SCOTTISH HOSPITALS INQUIRY

Bundle 12 – Substantive Core Participant responses to Provisional Position Papers – Volume 1 (of 3)

Responses to Provisional Position Paper 6 – The Commission and Validation Process Utilised for the Royal Hospital for Children and Young People and Department for Clinical Neurosciences

IEF 03

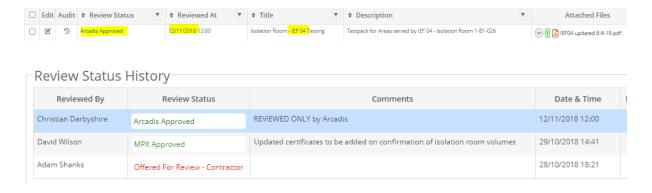
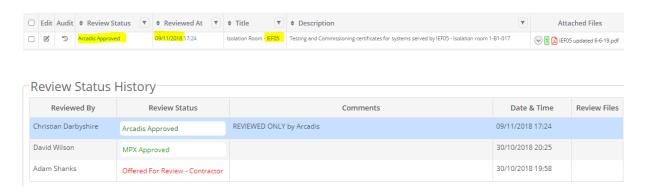
6.2 Further at paragraph 7.2 of PP6 the Inquiry ask if parties are able to provide:

6.3 This information is available on Zutec, relevant extracts are copied below:
